CERTIFICATE OF THE SECRETARY OF ENERGY AND ENVIRONMENTAL AFFAIRS
ON THE
EXPANDED ENVIRONMENTAL NOTIFICATION FORM

PROJECT NAME	: Unified Parkway Industrial Development
PROJECT MUNICIPALITY	: Millbury and Sutton
PROJECT WATERSHED	: Blackstone
EEA NUMBER	: 16593
PROJECT PROPONENT	: UGPG RE Sutton LLC
DATE NOTICED IN MONITOR	: August 24, 2022

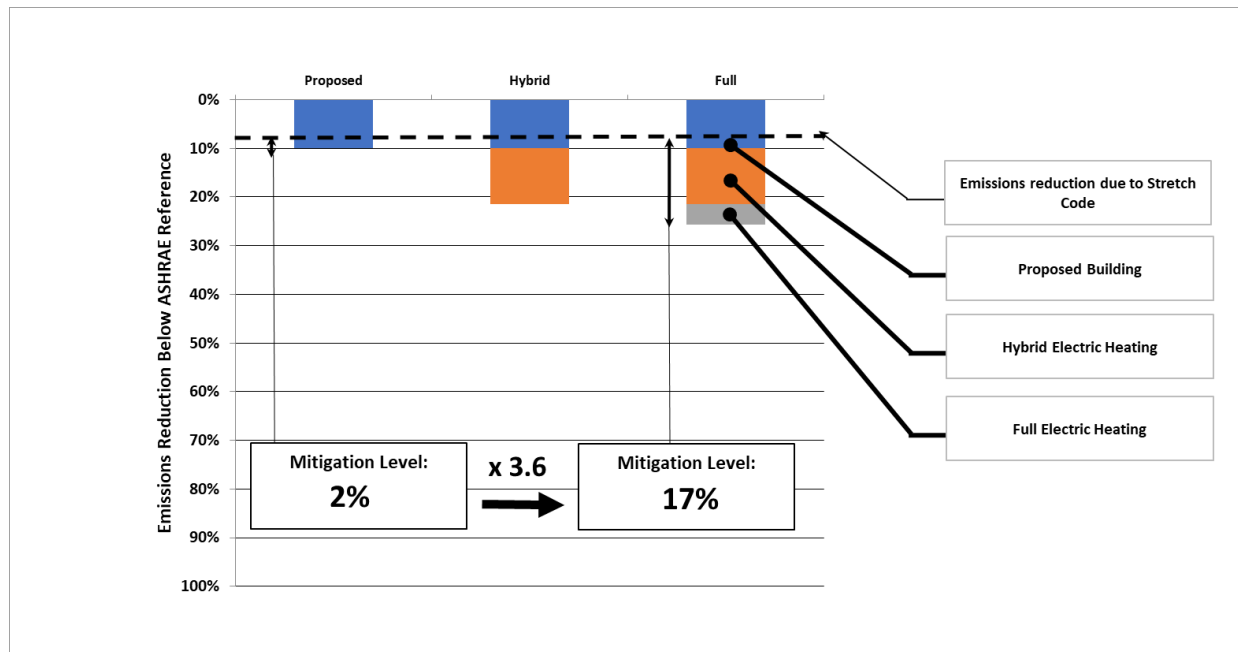
The building has near-negligible emissions mitigation and is essentially a "code" building.

Mitigation can be improved by a factor of more than **x3** with hybrid electrification. This approach is commonly used by other warehouse buildings reviewed by DOER. As proposed, this warehouse project represents a **significant outlier** compared to other warehouse projects. At a minimum, hybrid electrification should be used to address the insufficient mitigation. Ventilation energy recovery and reduced air-infiltration should also be evaluated.

The proponent states that hybrid electrification is not feasible based on cost. However, this decision is based on a near fully-redundant electric and gas approach (electric sized to 67% peak, gas sized to 100% peak). Instead, the proponent should evaluate a traditional hybrid electric and

gas approach (electric at 20% peak, gas at 100% peak). A “right-sized” hybrid electrification approach could cost **65% less** than described in the submission.

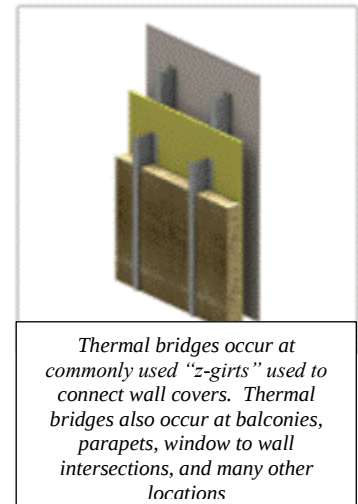
Thermal breaks should be thoroughly incorporated into the design to ensure that the intended wall, window, and roof performance is being delivered. The thermal bridge accounting method described in the Building Envelope Thermal Bridging Guide² can be used. This design guide now has a web-based database³

All window and wall thermal values should reflect the thermal values after accounting for thermal bridges. Unfortunately, many projects do not typically account for thermal bridges other than wall studs and delivered envelope performance is likely lower, potentially significantly lower, than intended by design.

The project should confirm that reported envelope performance values include the effect of thermal bridges.
